FILE #SPR-95-58

TITLE HEADING: Site Plan Review - Flood Plain
Permit - Sutherland's

LOCATION: 2405 F Road

FILE: #SPR 95-58
DATE: March 31,1995
STAFF: Michael Drollinger
REQUEST: Site Plan Review/Flood Plain Permit
LOCATION: 2505 F Road
ZONING: HO

1 SCHEMATIC SITE PLAN
SCALE: 1" = 30'-0"

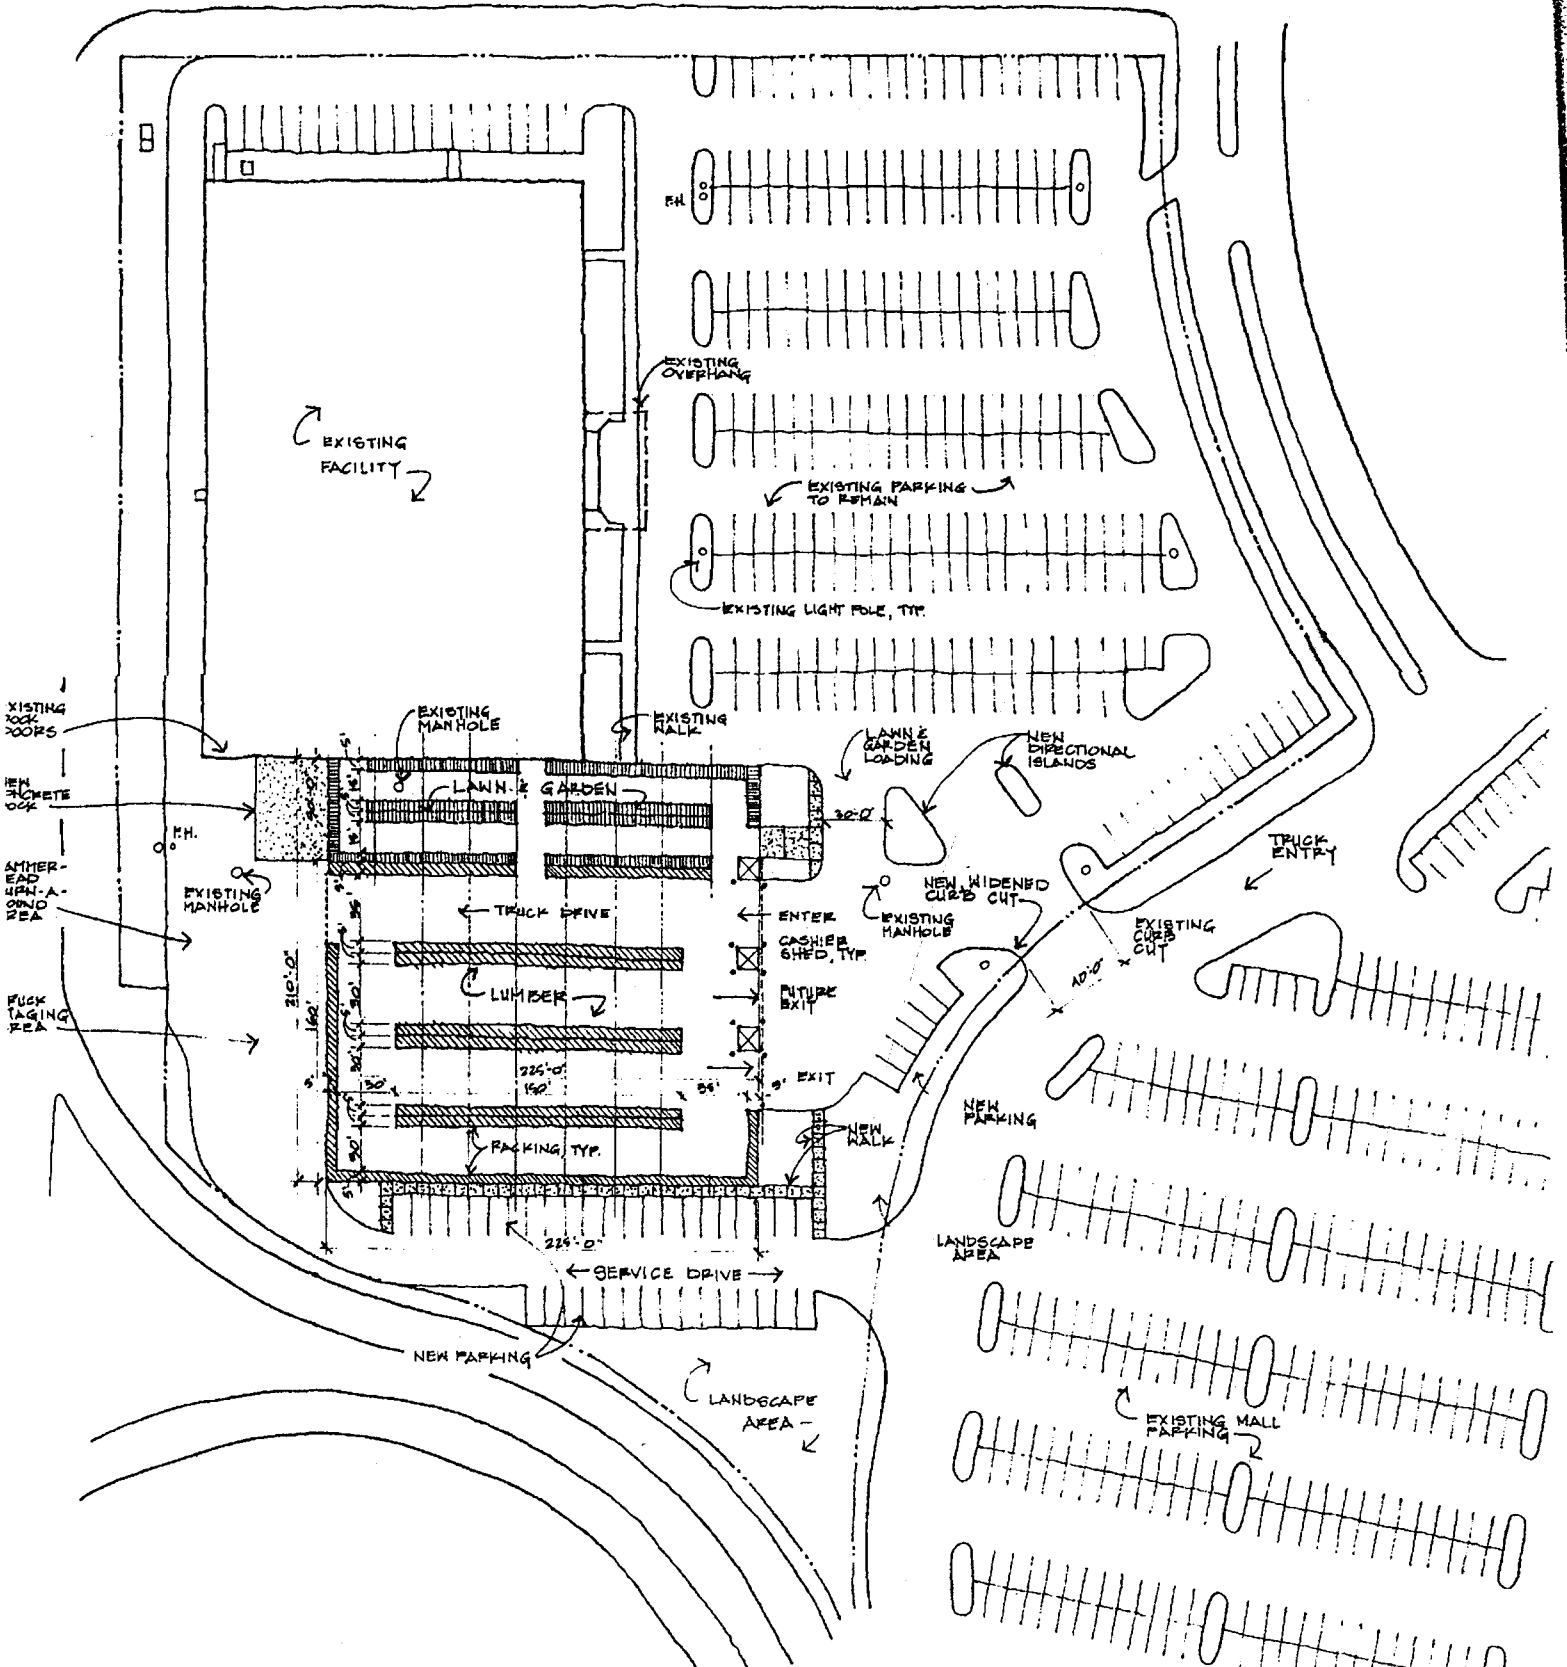
STAFF COMMENTS:

1. Parking requirement for new addition is calculated as follows: Lawn and Garden area = 13,750 square feet X 1space/200 sq. ft. gross sales area = 69 spaces required. Lumber sales area is not included in required parking calculation. Petitioner must provide gross sales area for existing building under renovation so that determination of the overall parking requirement can be made.
-
